Service Letter No. 250

SUBJECT: PA-23 Service Bulletin No. 138

MODELS AFFECTED: PA-23, Serials 23-1 to 23-208 inclusive

PIN INSTALLATION - Hyd. Cyl. Assy.

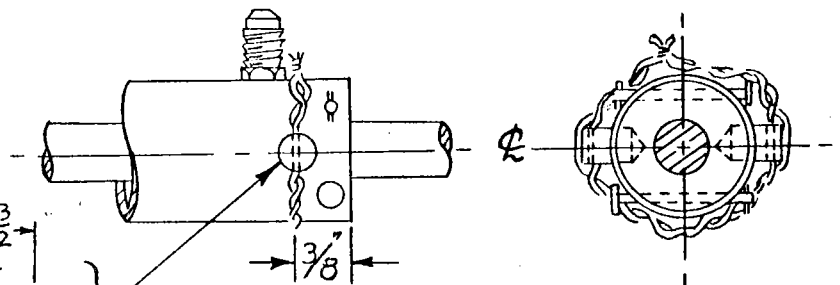
Due to the inability of our vendor to supply adequate quantities of replacement cylinders, part 455 927, to comply with Service Bulletin No. 138, our Engineering Department has developed a modification which, when accomplished, will fulfill the requirements of Service Bulletin No. 138.

This modification, shown on the reverse side of this letter, can be accomplished on the cylinders which do not have upset or fractured cylinder housings. Extreme care should be exercised when drilling the .250 diameter hole to the proper depth. It is recommended that a depth gauge be used. Part 18829-00 can be manufactured locally or can be ordered through your nearest Piper Distributor at no charge.

DO NOT EXCEED 3/16" DEPTH  
WHEN DRILLING

Drill (2) holes  
.250/.252 Dia. x 3/16" deep

.032 Brass  
Safety Wire

Material  
#1018 Cold Roll Steel
